**ADDISON AIRPORT
BUILDING REPORT**

Facility Information: **Facility Name:** 4726 George Haddaway Dr.
Facility Contact: Lisa Pyles **Contact Phone:** 972-450-2878

Accessology Inspector Information:
Inspector: Karen Jackson **Date:** April 17, 2017
Email: Kjackson@accessology.com

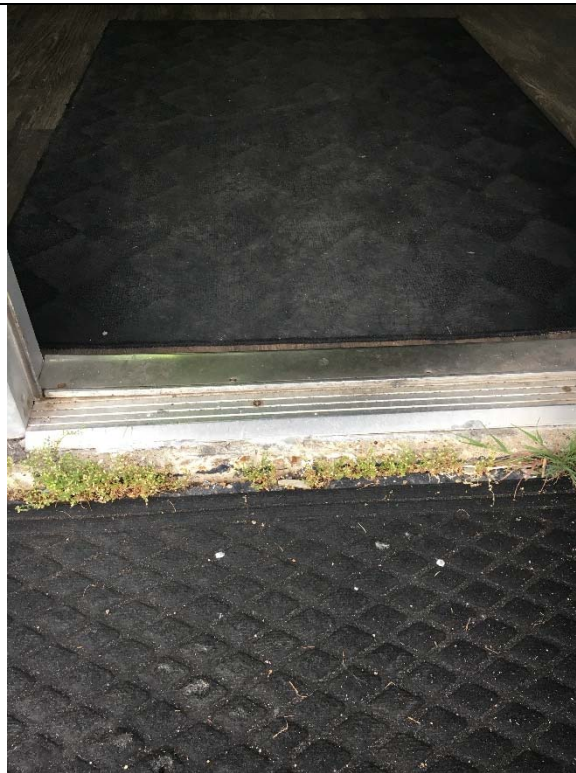
Violation 1 - There are no accessible parking spaces provided.

Violation 2 - The ground surface in the parking area is broken, uneven and unstable.

Possible Solutions: Add one van accessible parking space, an access aisle and compliant van parking signage.

Possible Solutions: Repave the area where accessible parking spaces will be added. Cost is included in Violation #1.

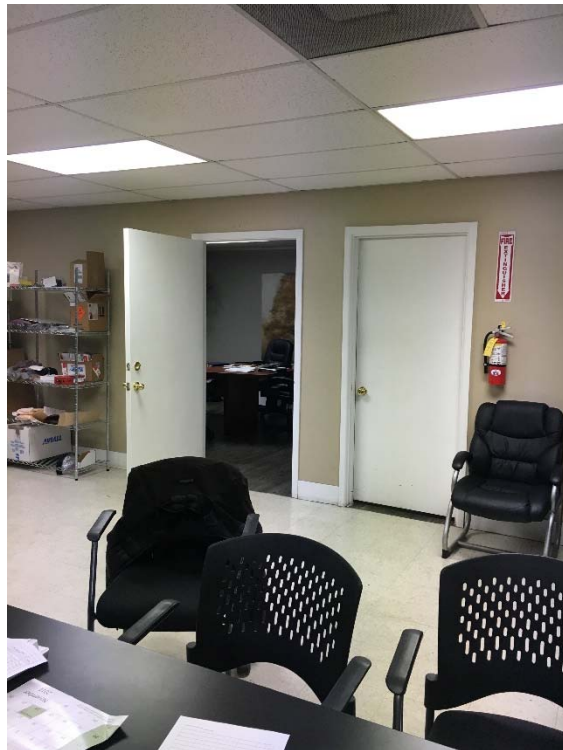
Violation 3 - The ground surface around the building is broken, uneven and unstable.

Violation 4 - The main entrance has a threshold that is greater than 1/2" and there is not a smooth transition from the porch area.

Violation 5 - The entrance door is only 28-1/2" wide where a minimum of 32" is required.

Violation 6 - The entrance into the airplane hangar area from outside has broken, uneven pavement.

Possible Solutions: Repave the accessible route leading to the building's main entrance.

Possible Solutions: Modify threshold.

Replace door to achieve 32" minimum clear width.

Repair broken pavement.
